ADDENDUM No. 3

**ORG #207 – San Jacinto Elementary School - Renovation
ORG #273 – Pleasant Grove Elementary School – Renovation**

DALLAS INDEPENDENT SCHOOL DISTRICT

11/01/2024

ENLARGED FINISH PLANS & MILLWORK DETAILS

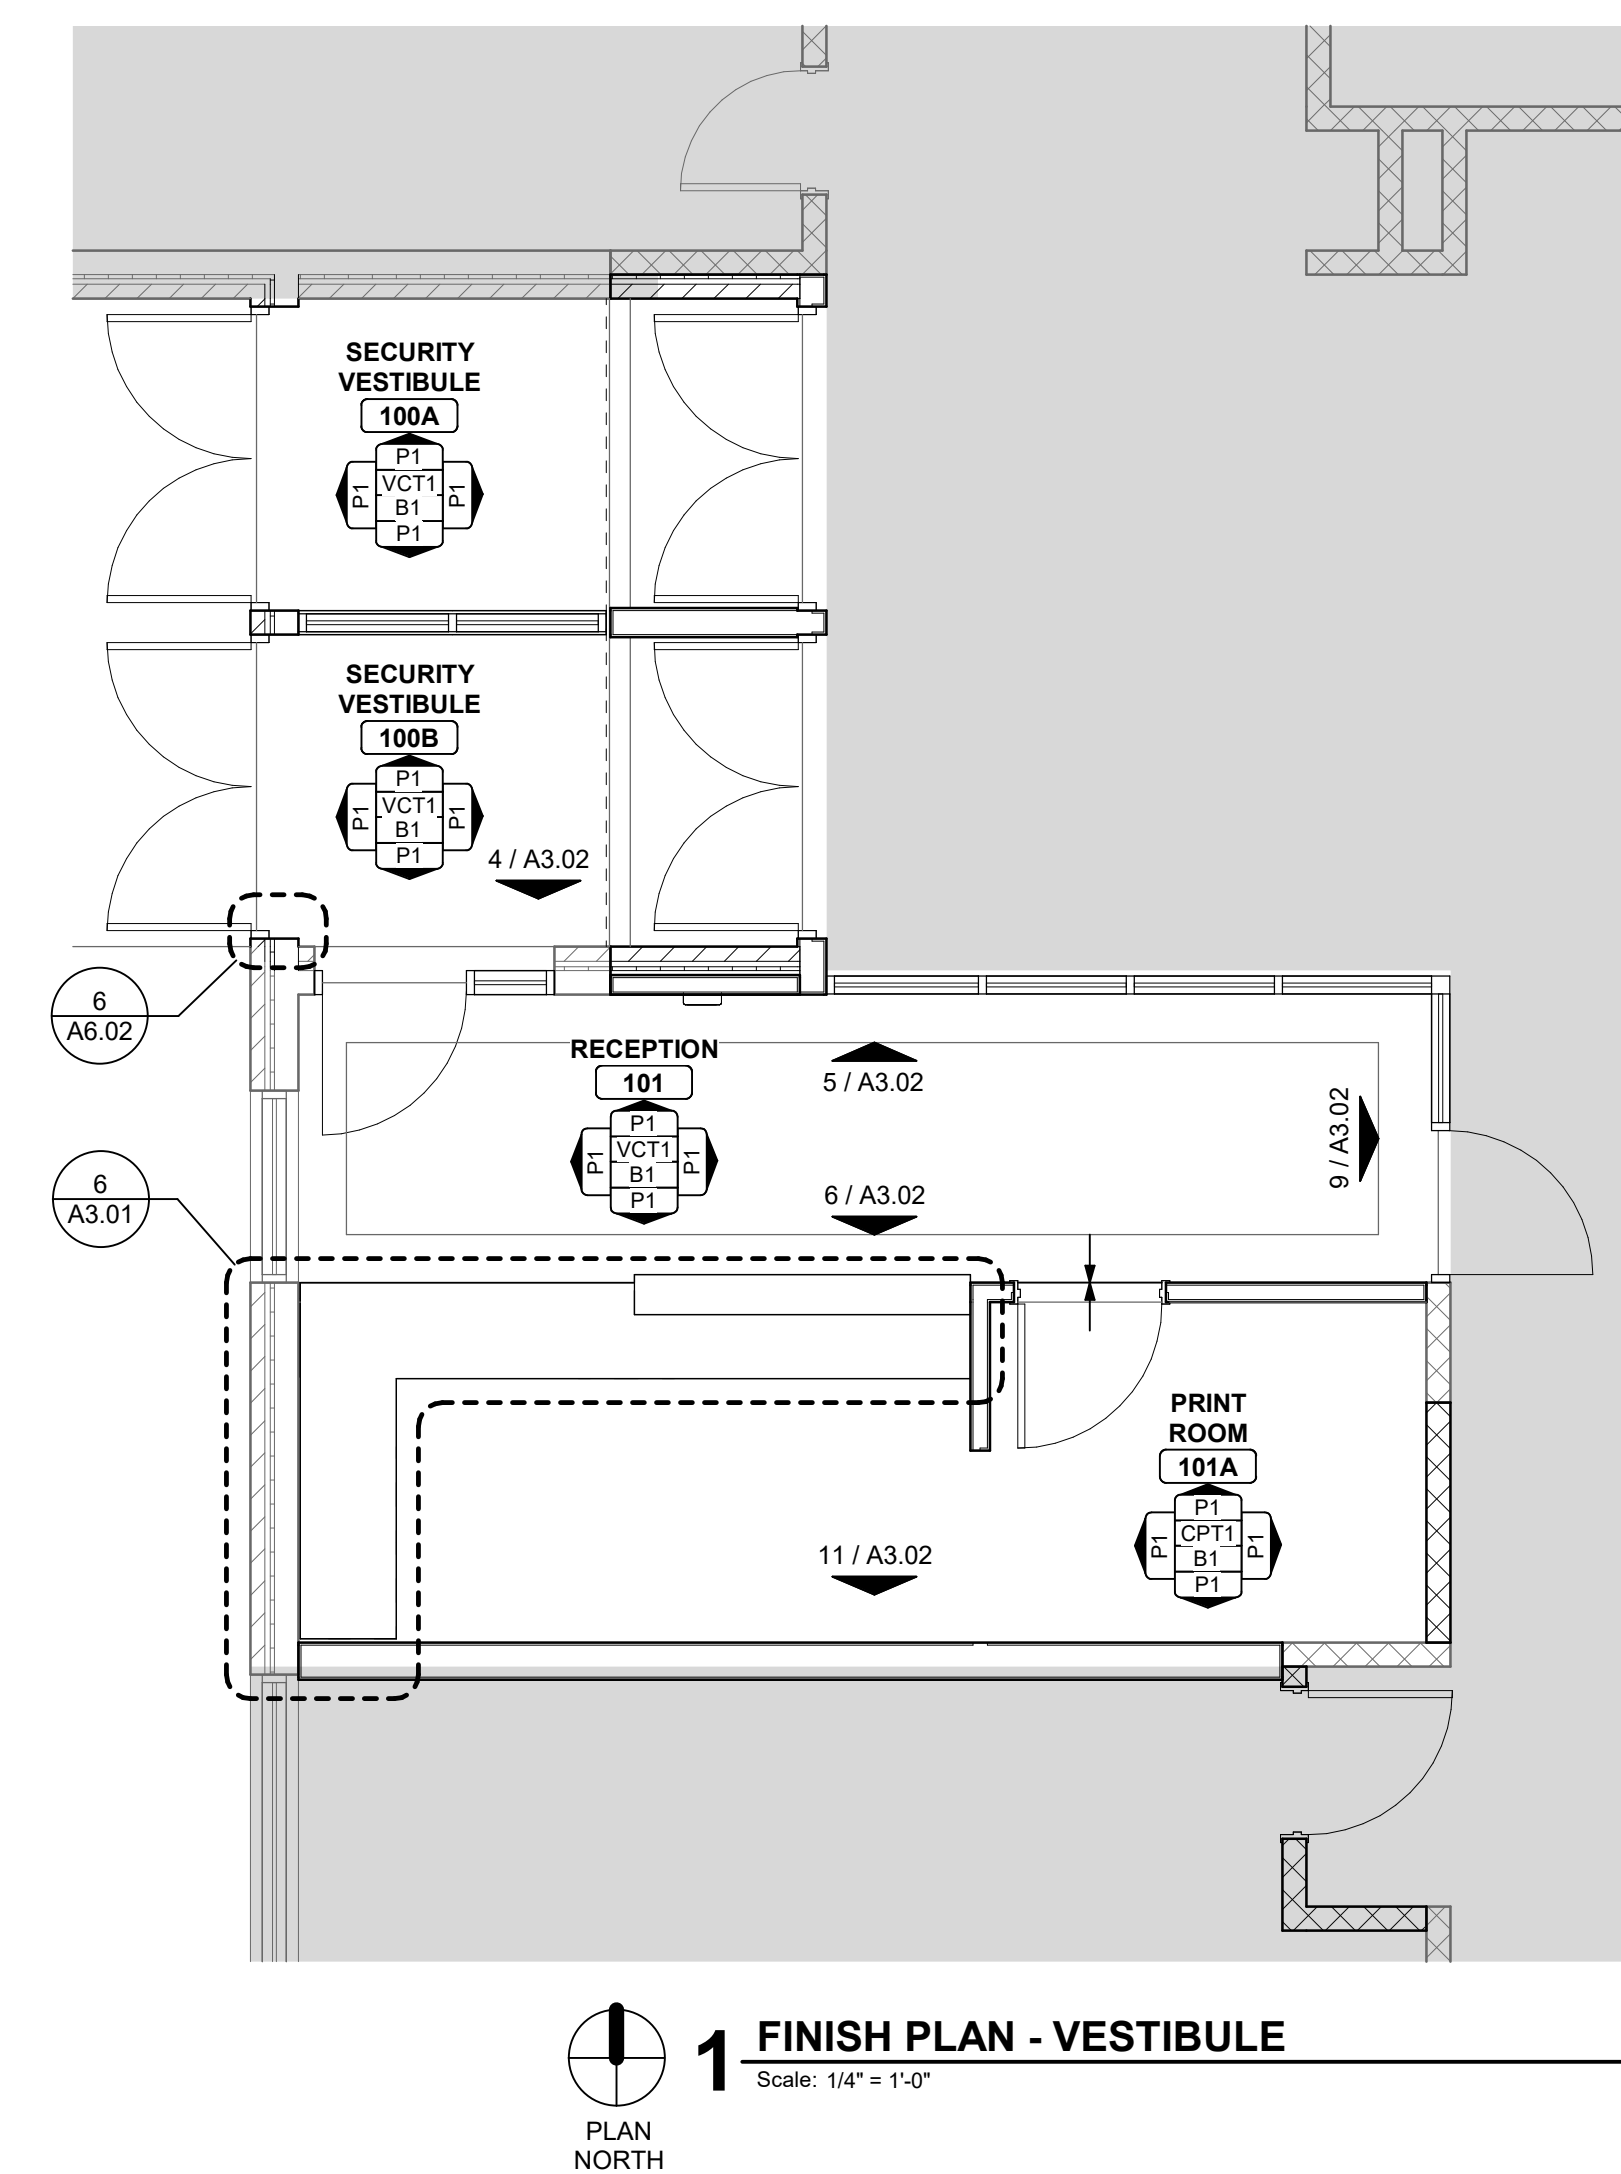
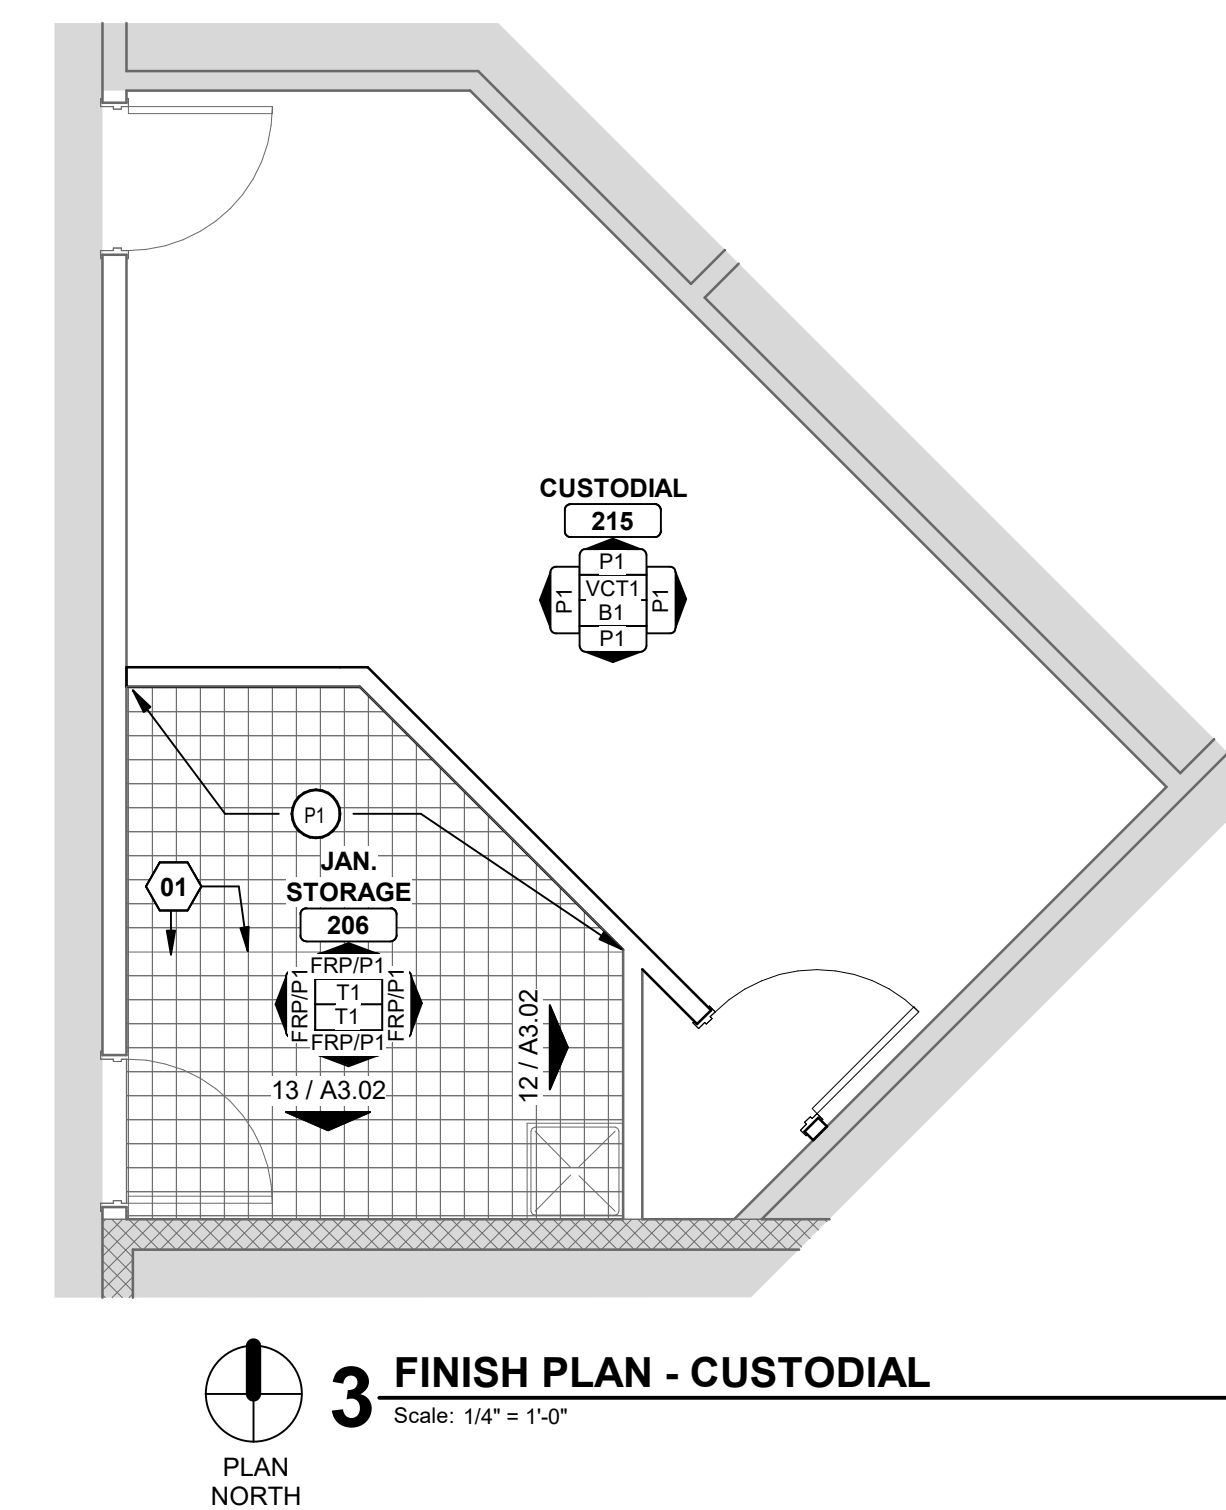
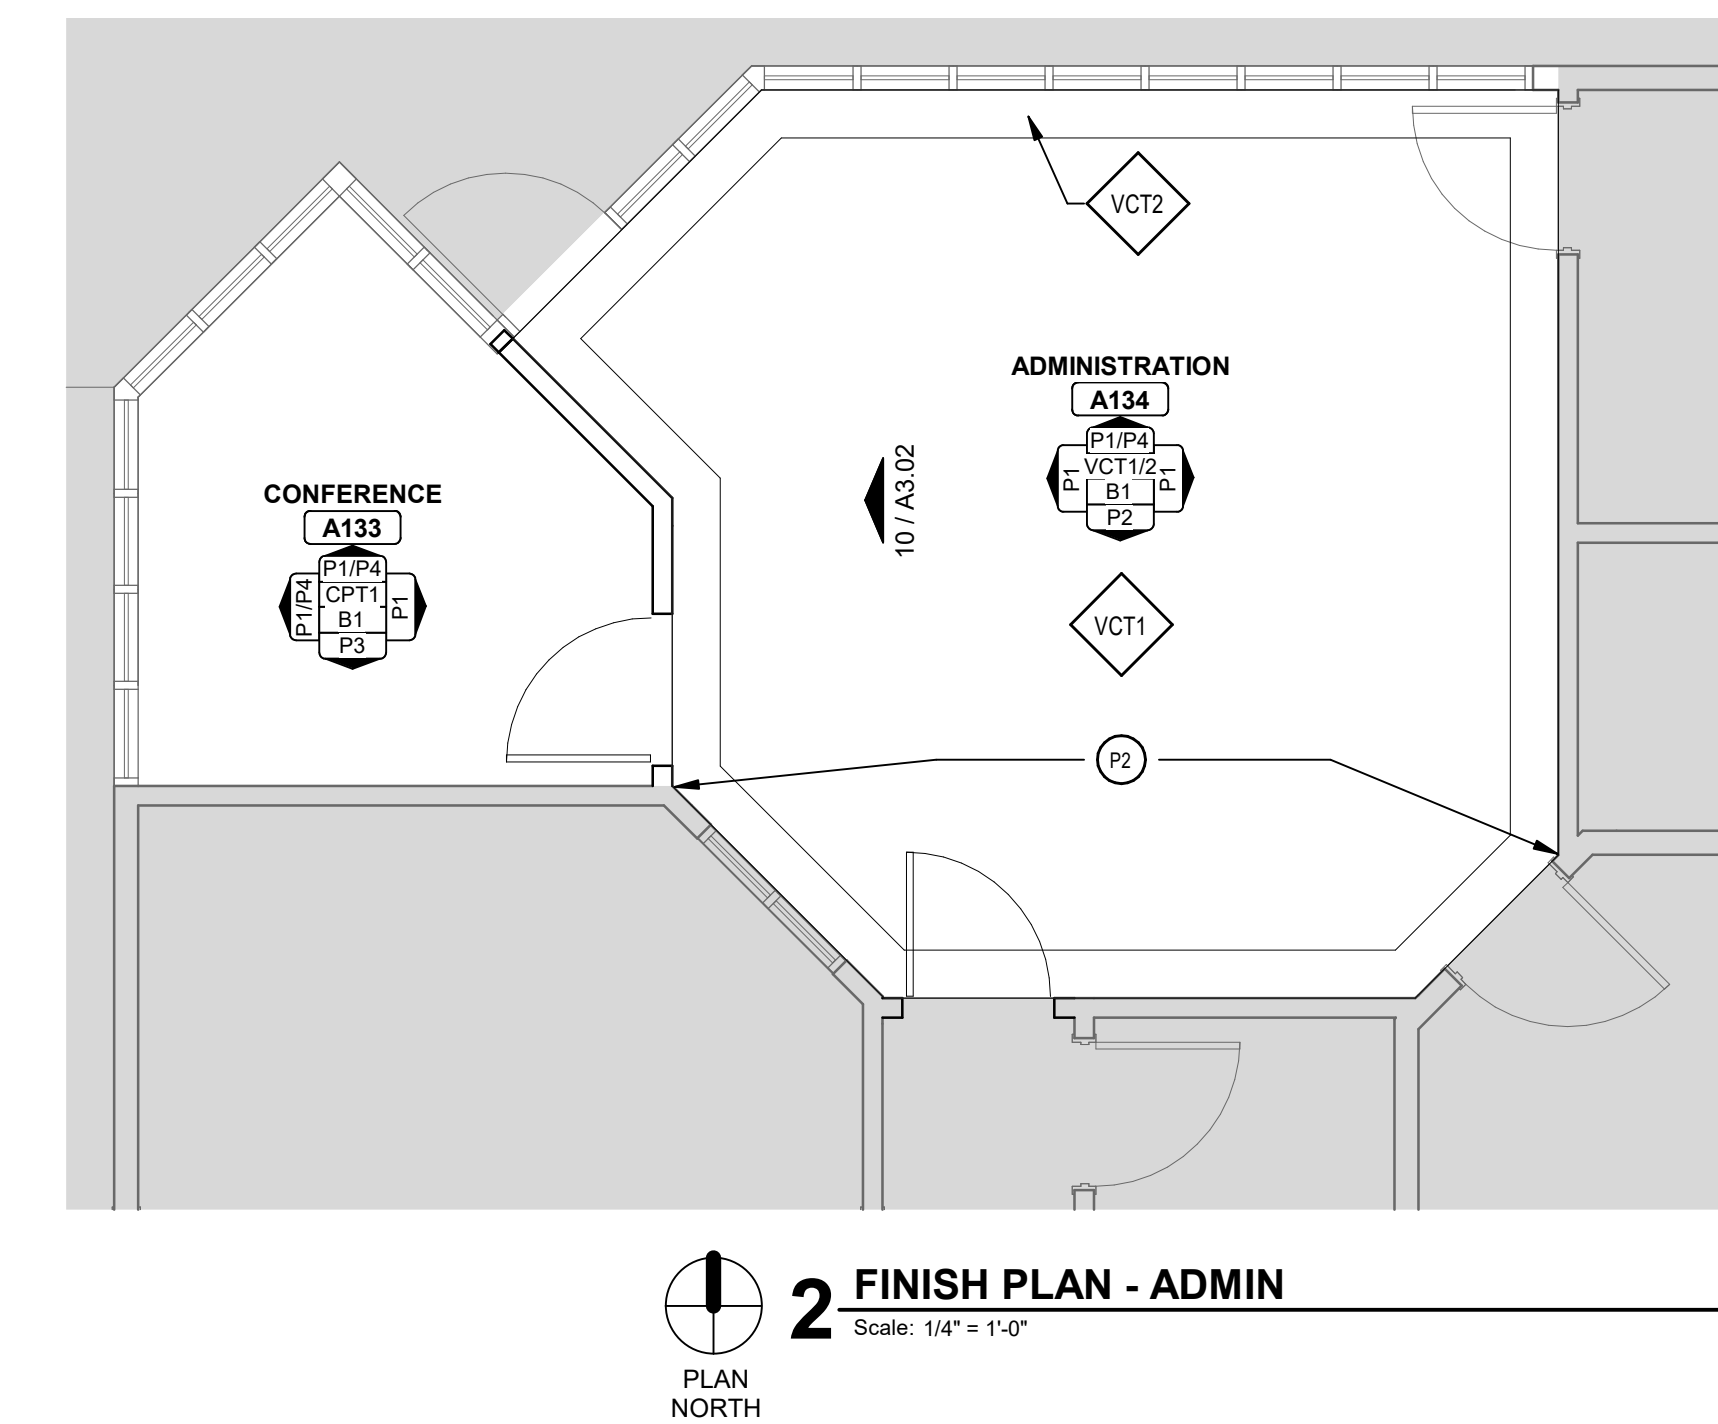
- Replace sheet with the revised attached A3.01.
 - Carpet to be Mohawk Datum in color Basalt as indicated.
- Replace sheet with the revised attached A1.01.
 - ALTERNATE: Mild-detergent medium power wash to be done at front of building only as indicated.
 - ALTERNATE: Provide sandblasting, prime & repaint all handrailing, guard railing and exposed metal at ramps as indicated.
